Bushfire Statement of Compliance of APZ at 231-233 McCarrs Creek Road Church Point (Address)

In response to your request for a Bushfire Statement of Compliance of Inner Protection Area (IPA) Asset Protection Zone (APZ) for the above address, we have completed a review of the arborist report on 19/09/2023.

Below is extracts from our assessment of the Arborist Report and Tree Retention Plans. This is not the Bushfire Compliance of Design Statement as the comments in the right columns identify some areas where compliance is not achieved and requires further consideration by the Arborist.

Appendix 1 – Extracts from Arborist Report

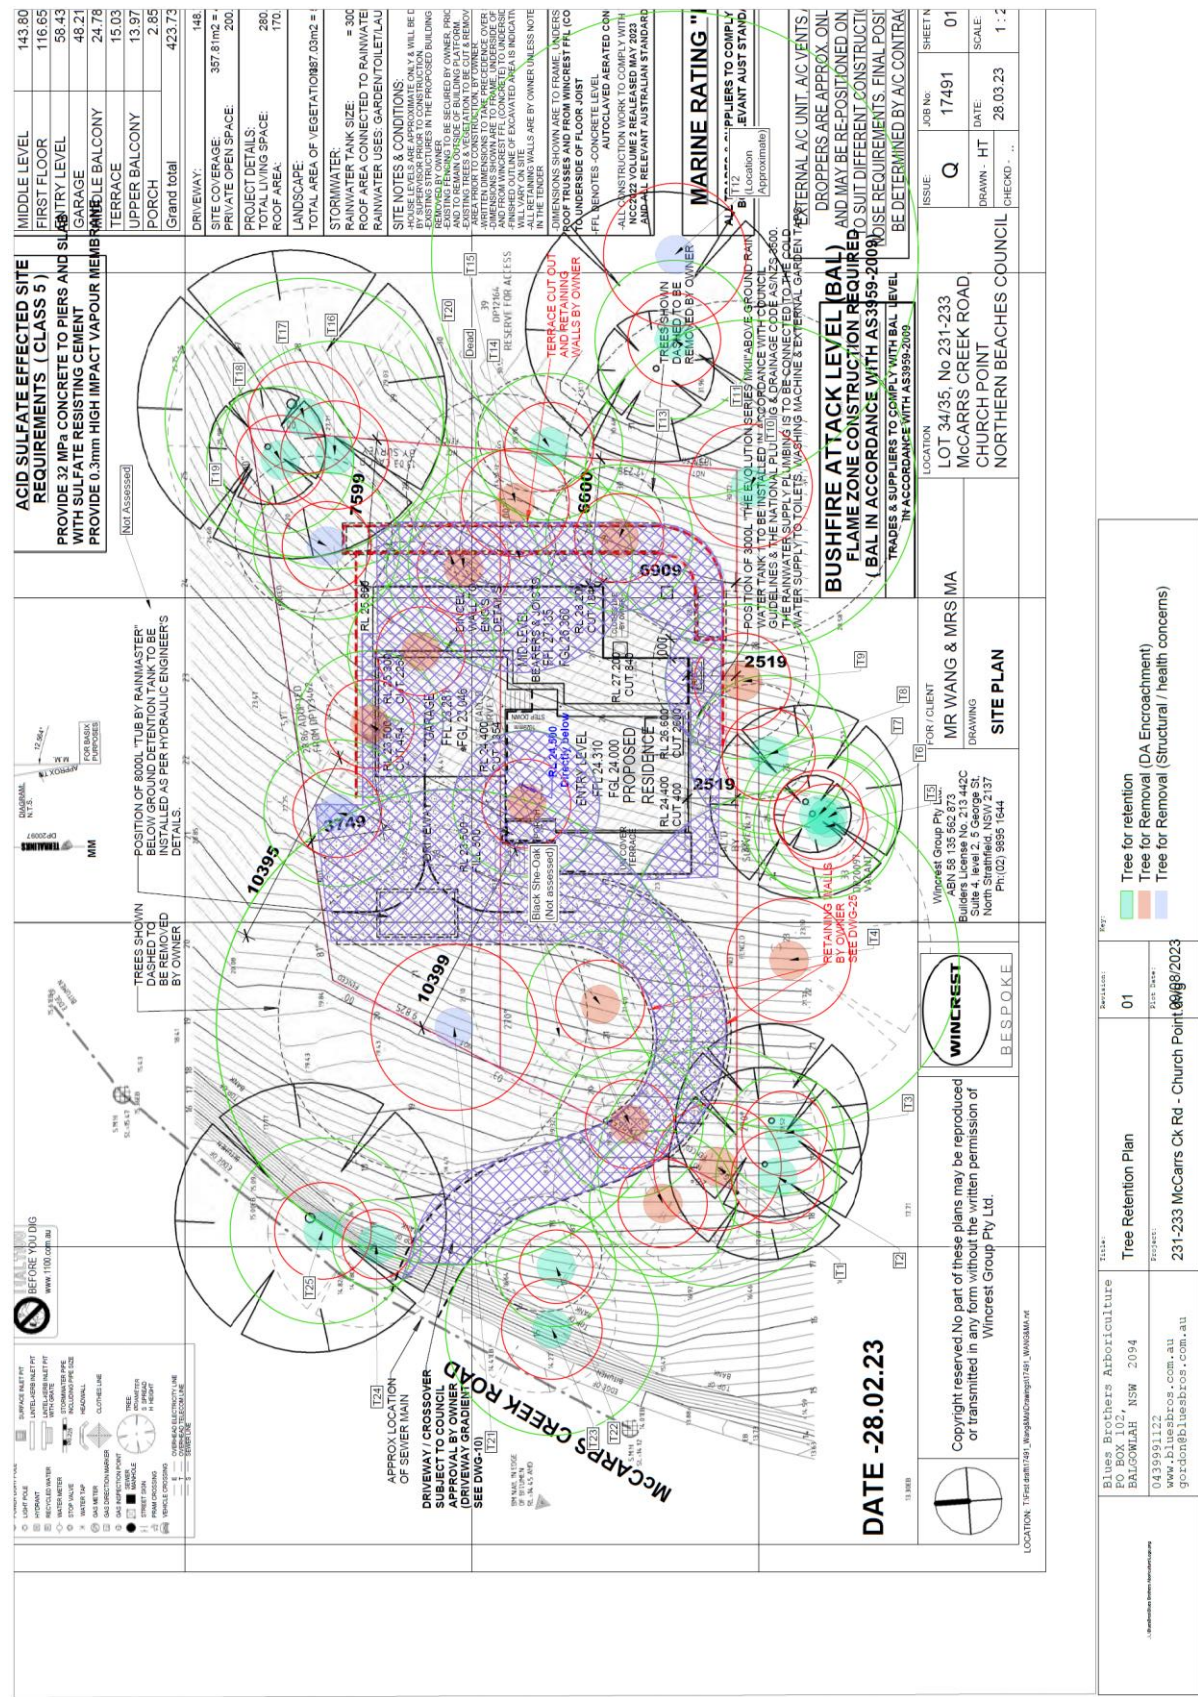
Planning For Bushfire Protection 2019 Appendix 4 Asset Protection Zone requirements	
Trees	
tree canopy cover should be less than 15% at maturity	<p>Not Achievable without further significant tree removal</p> <p>The trees nominated for retention in the Arborist Report are:</p> <ul style="list-style-type: none"> • T2 • T3 • T5 • T6 • T7 • T8 • T10 • T11 • T14 • T16 • T17 • T18 <p>Calculations of canopy cover based on the Tree Retention Plan, Rev 01, dated 09/08/2023 contained within the Arborist Report are as follows:</p> <p>Total tree canopy cover required by PBP: = 15% x 744.84m² (site area) = 111.7m²</p> <p>Total Tree Canopy Cover of trees to be retained from Tree Retention Plan: = 533.1m² / 744.84m² = 71.6%</p> <p>The Tree Retention Plan prepared by the Arborist nominates the following trees for removal:</p> <ul style="list-style-type: none"> • T1, T4, T9, T12, T13, T15, T19, T20, T21

It is therefore determined that the 15% tree canopy cover requirement is not achievable without significant further tree removal.
trees at maturity should not touch or overhang the building	Not Achieved Provide a plan note that trees will be pruned so that they do not touch or overhang the building. We recommend consultant with the Arborist and/or Council as the majority of overhanging branches belong to trees outside the subject site boundaries and that pruning large portions of some trees may compromise their health and stability such as T7, T8 &16.
lower limbs should be removed up to a height of 2m above the ground	Add notation to the plans
tree canopies should be separated by 2 to 5m and	Not Achieved – The tree canopy cover is all connected, there is no 2-5m tree canopy separation indicated by the Tree Retention Plan. As such, we recommend the Arborist provides for additional tree removal.

preference should be given to smooth barked and evergreen trees	Trees are existing
Shrubs	
create large discontinuities or gaps in the vegetation to slow down or break the progress of fire towards buildings should be provided	No details provided to demonstrate compliance. Add notations to final plans
shrubs should not be located under trees	No details provided to demonstrate compliance. Add notations to final plans
shrubs should not form more than 10% ground cover	No details provided to demonstrate compliance. Add notations to final plans
clumps of shrubs should be separated from exposed windows and doors by a distance of at least twice the height of the vegetation	No details provided to demonstrate compliance. Add notations to final plans

Standards for Asset Protection Zones, NSW Rural Fire Service	BFCS Comment
ensure that vegetation does not provide a continuous path to the house	Not Achieved - Vegetation along boundaries is to be broken up into clumps
remove all noxious and environmental weeds	Add notations to plans
plant or clear vegetation into clumps rather than continuous rows	Add notations to plans
prune low branches two metres from the ground to prevent a ground fire from spreading into trees	Add notations to plans
locate vegetation far enough away from the asset so that plants will not ignite the asset by direct flame contact or radiant heat emission	Add notations to plans
plant and maintain short green grass around the house as this will slow the fire and reduce fire intensity. Alternatively, provide non-flammable pathways directly around the dwelling	Add notations to plans
ensure that shrubs and other plants do not directly abut the dwelling. Where this does occur, gardens should contain low-flammability plants and non flammable ground cover such as pebbles and crush tile	Add notations to plans
